DESIGN REVIEW BOARD MEETING PACKAGE

TITLE: DESIGN REVIEW FILE: DESIGN-2021-20-SEPTEMBER-6a 203 Fitzroy Street (PID #346486) OWNER: Canadian Mental Health Association (CMHA) APPLICANT: Nine Yards		
MEETING DATE: SEPTEMBER 20, 2021		Page 1 of 7
DEPARTMENT: Planning & Heritage	ATTACHMENTS: <ul style="list-style-type: none"> A. Original design proposal (April 26, 2021) B. Design Reviewer comments on original design proposal (May 12, 2021) C. Staff Recommendation Report: Major Variance Request (August 23, 2021) D. Revised design proposal (August 4, 2021) E. Design Reviewer comments on revised design proposal (August 12, 2021) F. Design Standards for the 500 Lot Area 	
SITE INFORMATION: Ward No: 1 – Queens Square Existing Land Use: Vacant Official Plan: Downtown Mixed-Use Neighbourhood Zoning: Downtown Mixed-Use Neighbourhood (DMUN)

DESIGN REVIEWER COMMENTS: REVISED DESIGN PROPOSAL (August 12, 2021)

TITLE: DESIGN REVIEW FILE: DESIGN-2021-20-SEPTEMBER-6b 55 CHESTNUT STREET (PID #361527) OWNER: 11126105 CANADA INC.		 CHARLOTTETOWN
MEETING DATE: September 20, 2021		Page 1 of 4
DEPARTMENT: Planning & Heritage	ATTACHMENTS: A. Previously Approved Building Drawings (August 25, 2020) B. Revis

1 SITE PLAN
A:100 SCALE 1"=15'-0"

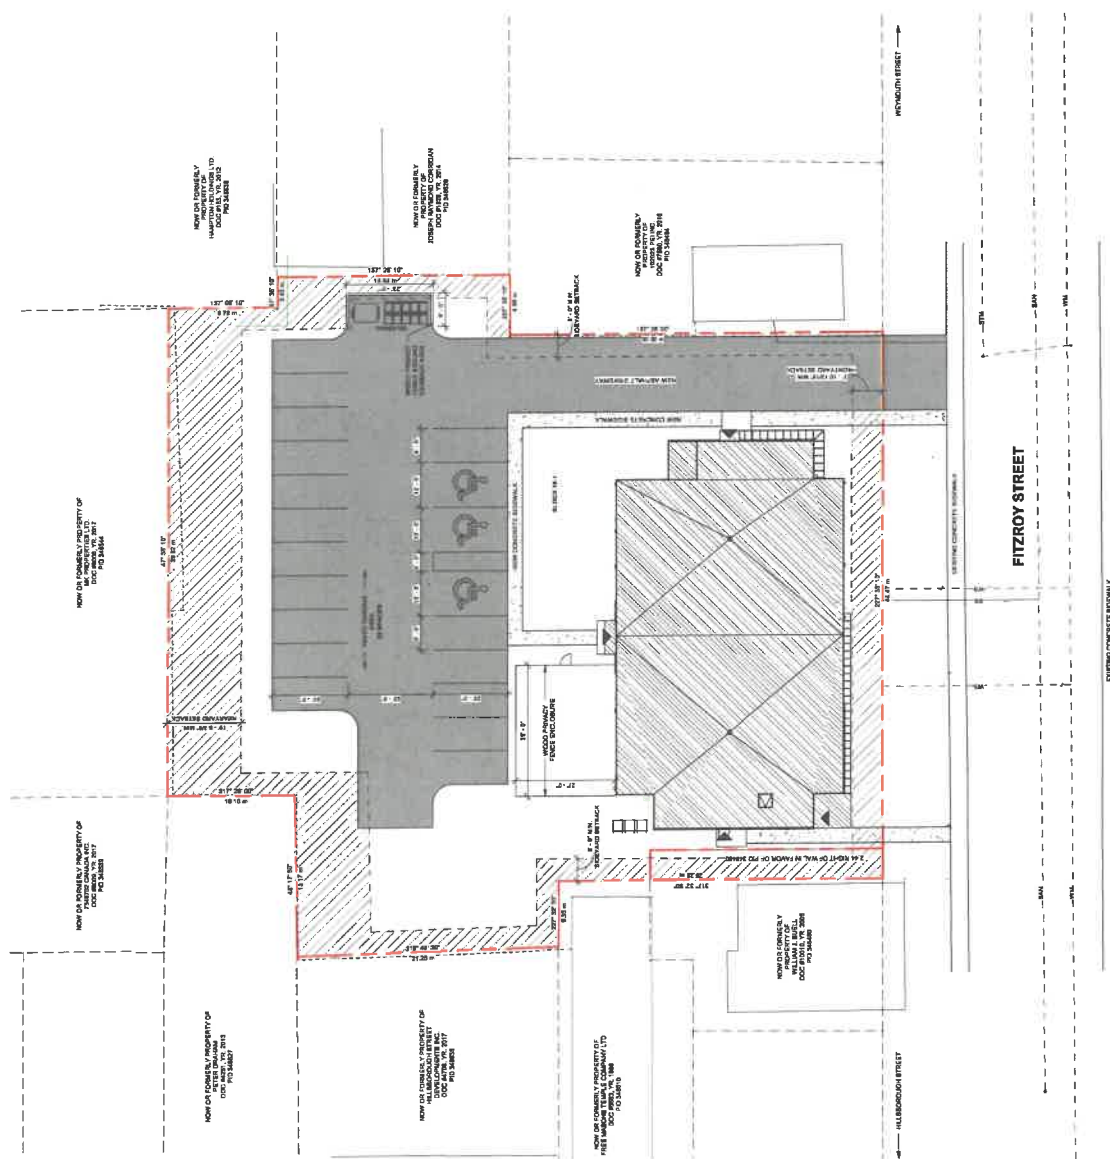
The proposed building is placed so that the building front aligns with the set back of the adjacent neighbours. There is a single vehicular access on the east side adjacent to the laundromat and which terminates in a parking lot at the rear of the site. The site plan does not indicate any landscaping details, but it does provide open space of 30 - 40 feet between the building and the parking. This provides a nice buffer and with attention to landscape detail and design, would provide nice opportunities for the tenants to enjoy an outdoor amenity space. The plans do not indicate how the garbage will be handled or where the snow will be stored.

1. Introduce soft and hard landscaping features.
2. Create exterior amenity spaces.
3. Revisit the apartment building main entrance. Both to define the entrances and provide shelter.
4. Consider canopies.
5. Revisit the entrances facing the parking lot.
6. The colours are in vogue now but is there a different more timeless palette?
7. Revisit the relationship of the apartment main entrance to the drive aisle.
8. Provide details on garbage storage and snow storage.

- Additional space provided in front of the tenant entrance.
- Canopies added to each building entrance.
- Additional landscaping provided around the building.
- Fenced area at the back of the building for tenant amenity space.
- Garbage and snow areas identified on the Site Plan.

3 SOUTH ELEVATION
A300 SCALE 1/8" = 1'-0"

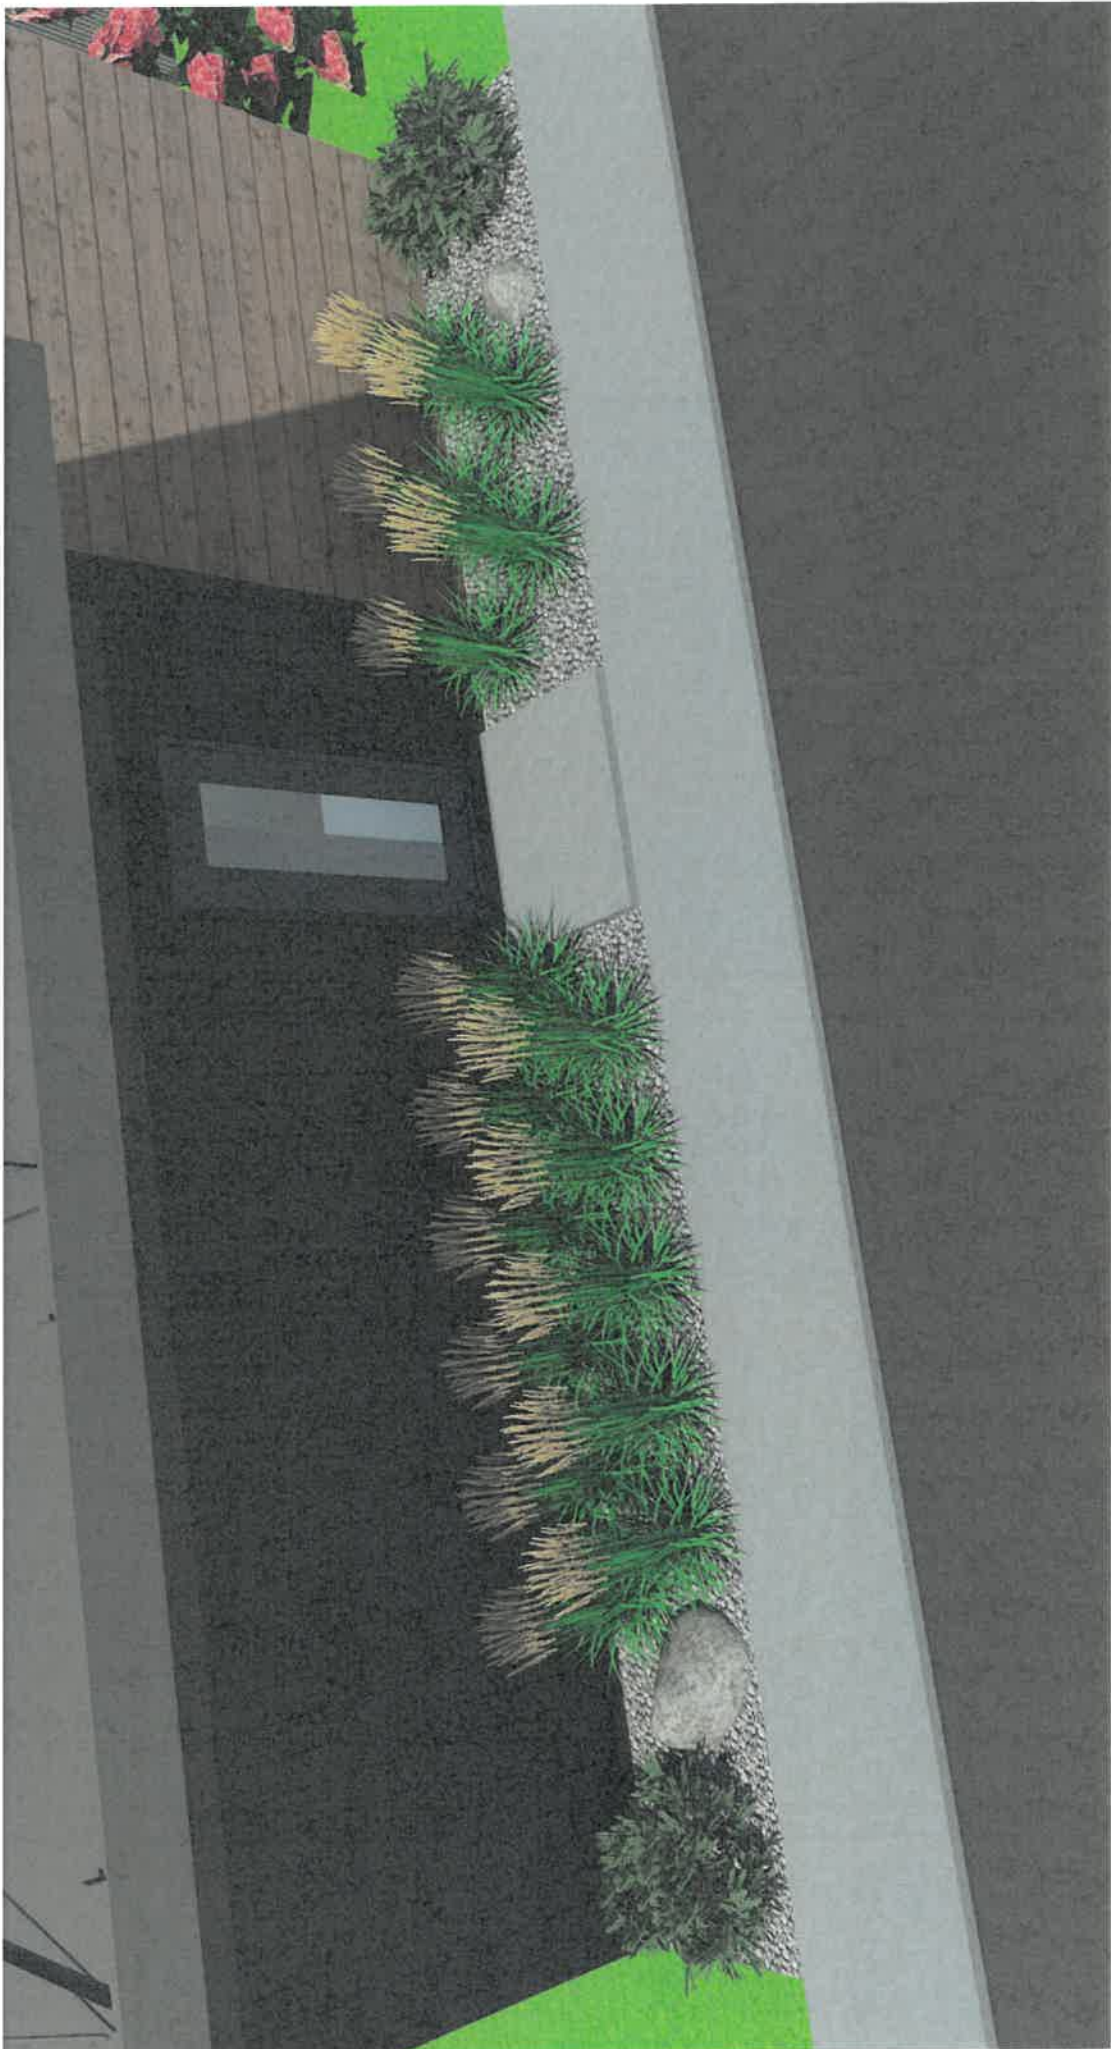
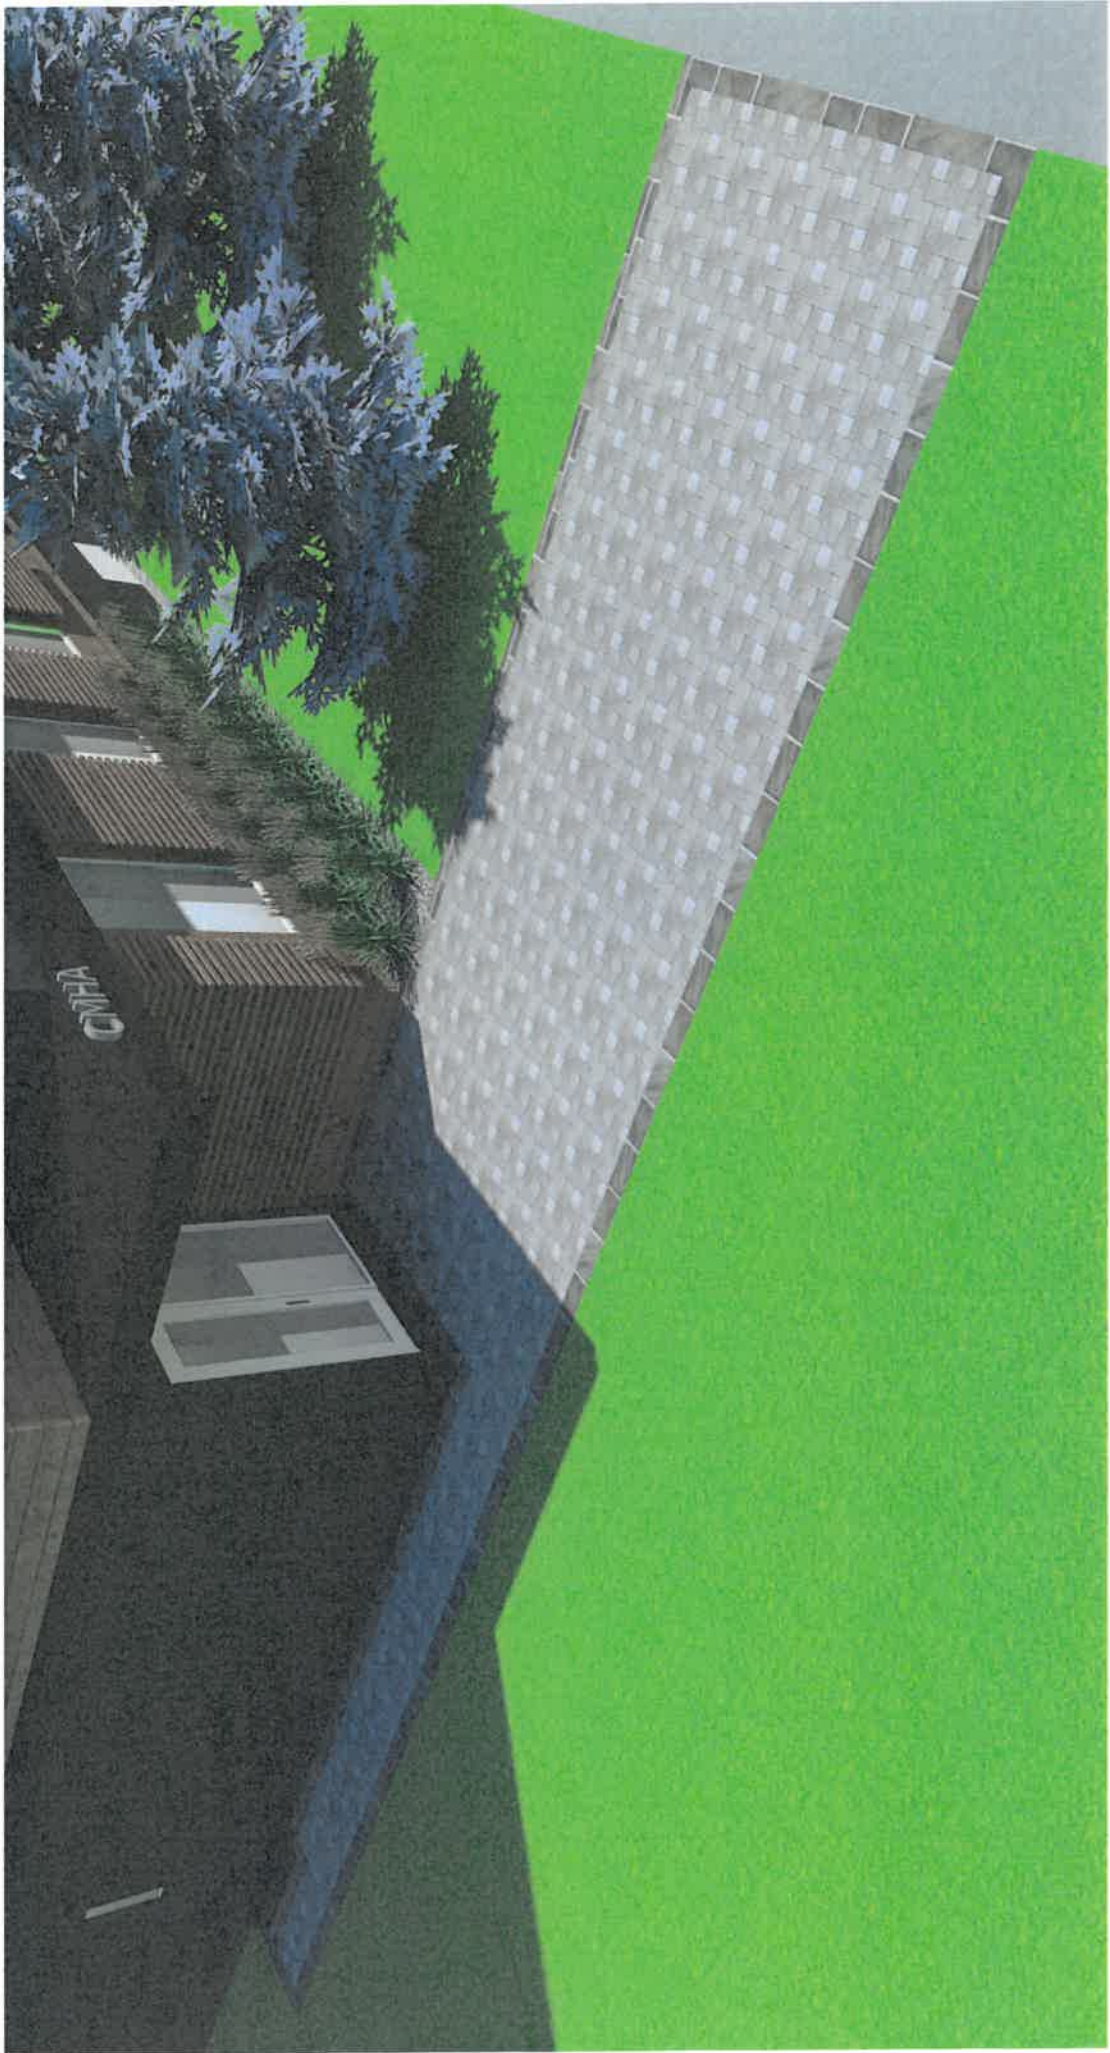
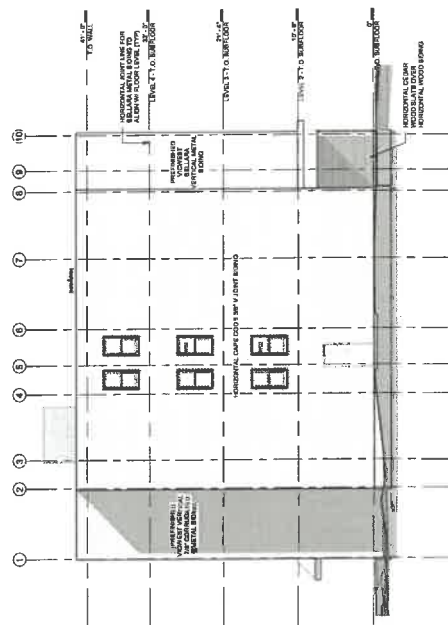
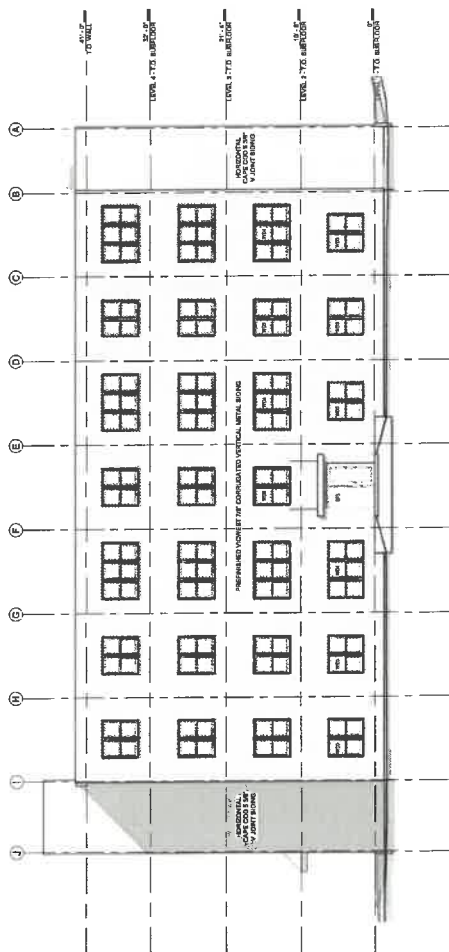
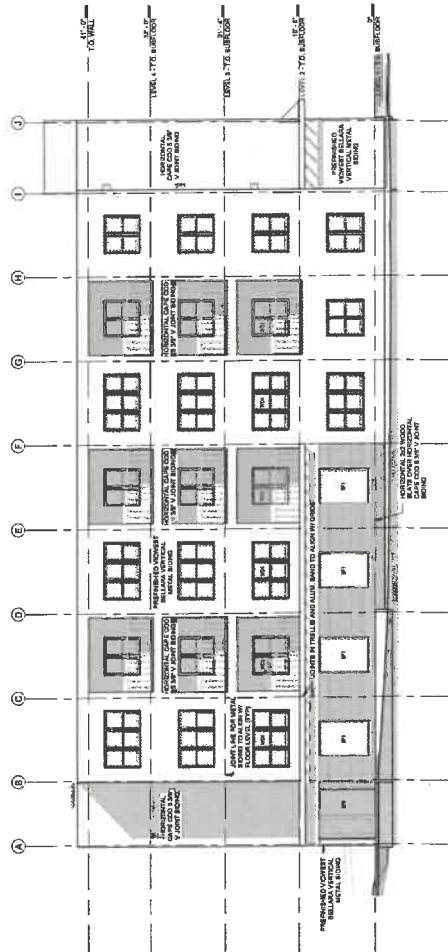
The dilemma in this instance is that the proposal provides much needed housing and is constructed using a modular stacking system. In reviewing the plans, the units are small and to consider stepping back the upper floors and maintaining the integrity of the structural design, the south or street facing units would not be functional. These street facing units are already smaller than those at the rear as they have provided balconies which reduces the interior usable area but do contribute amenity space while enhancing the façade.

Secondly, and perhaps in conjunction with the first comment, could the third and or four floors have a different façade treatment to visually respect the 1-1/2 and two-storey context of the block? That is, could the upper floors be more simply detailed and through choice of colour and material become a background to the richer design of the lower floors?

1 SOUTH ELEVATION
AS OF 2020

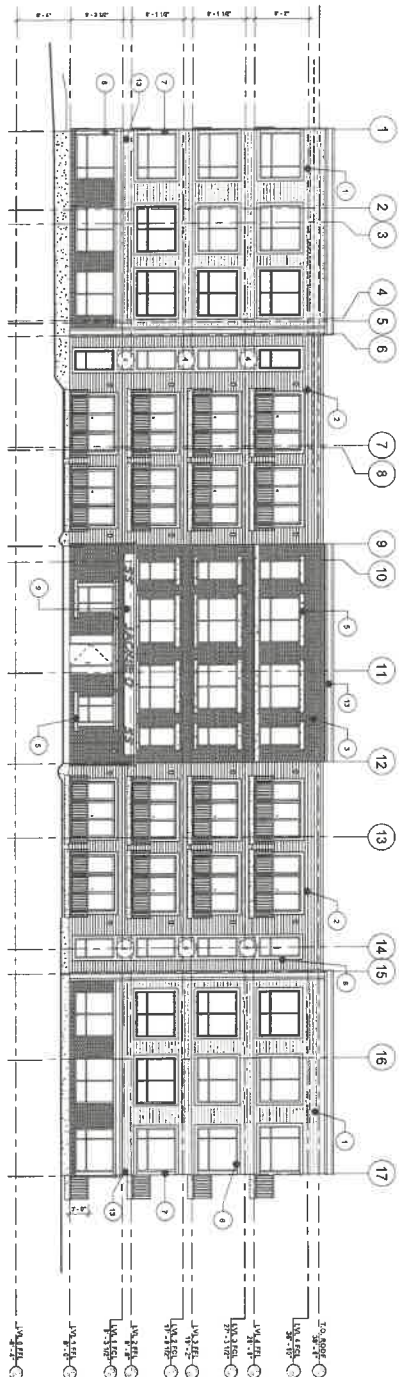
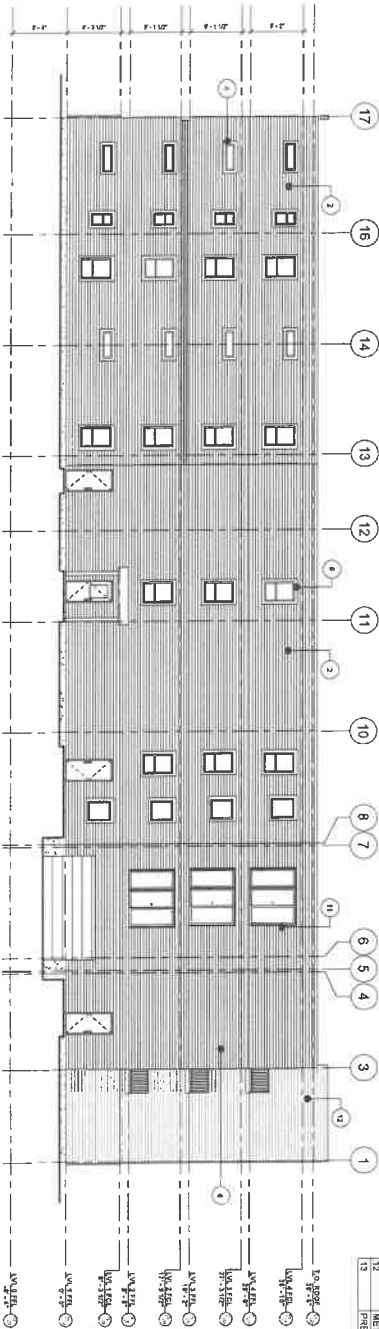
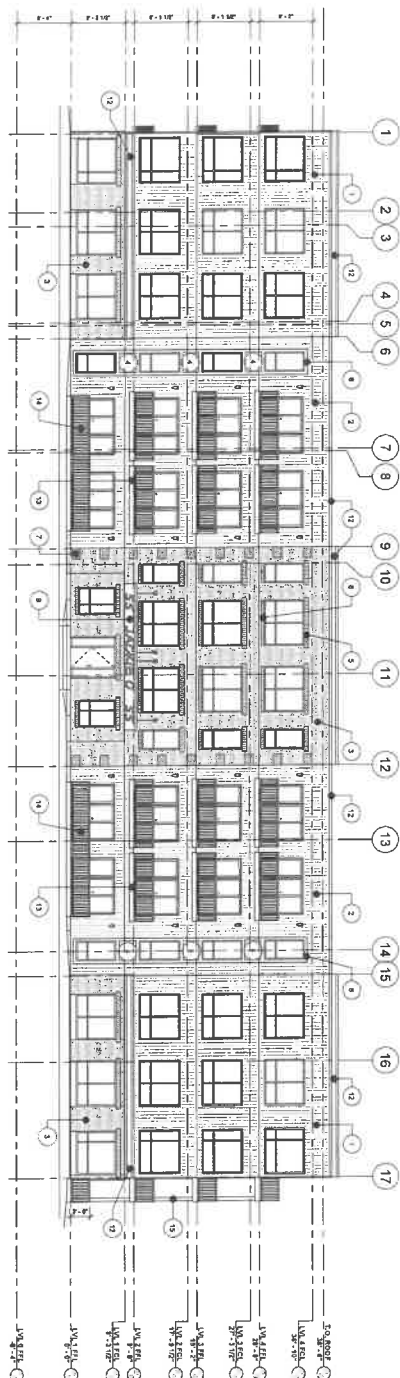
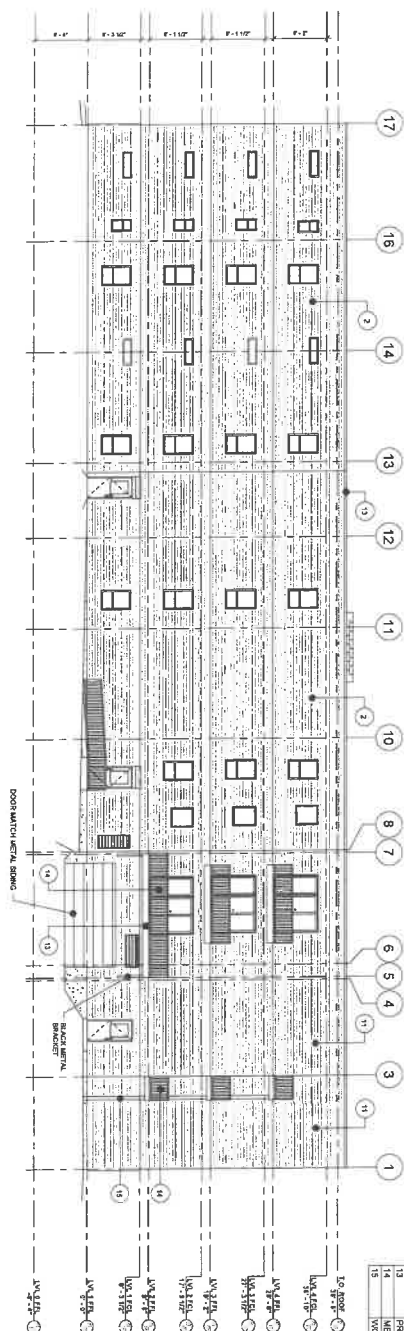
- ***Siding Orientation*** – The front-facing vinyl siding and side-facing metal siding have been installed vertically, as opposed to horizontally as per the revised elevations plan received August 25, 2020.

- ***Side Façade Design*** – The side façade does not match the design specifications in the revised elevations plan received August 25, 2020. The brick and vinyl front façade and black metal bands are shown to wrap around the side, extending approximately 44 ft to the step-back in the building footprint, then be accented in the black metal bands at the step-back. What was constructed does not match: on both sides the brick and vinyl front façade wraps less than half the distance proposed by the revised plan. The remaining side façade meant to be vinyl, brick and metal bands to match the front, uses the rear siding instead. These alterations did not receive an amendment to the Development Agreement nor approval by the Design Review Board.

- ***Balcony Design*** – The six balconies on the western side of the development, and the four balconies on the eastern side, have been built using wooden support posts as opposed to cantilevers as per the revised elevations plan received August 25, 2020. The wood support post balconies do not match the balconies on the front of the building (which use cantilevers).

- ***Black Metal Accent*** – Currently, there is no prefinished black metal bands. The cornice trim and left and right-most sections (both front and side façades) are to be accented with the prefinished black metal bands as per the revised elevations plan received August 25, 2020.

- ***Cornice Trim*** – All sections of the front façade have been built with cornice trims. The revised elevations plan received August 25, 2020 shows that cornice trim only be included on the left, middle, and right-most sections of the front façade. Furthermore, the cornice trim is remains unfinished, as opposed to being clad in the prefinished black metal bands. As it is unfinished, exposed fasteners used to secure the cornice trim are evident. Section 7.4.4 of the Zoning and Development Bylaw does not permit the use of exposed fasteners on front façades.

- **Brick** – The middle section is clad in brown and black brick as opposed to what was stated on the revised elevations plan received August 25, 2020, which was brown brick only. Furthermore, the square, black quoins lining the edge of the middle section were not displayed in the submissions.

- **Lintels** – The lintels have been constructed using the black bricks as opposed to stone, as stated in revised elevations plan received August 25, 2020.
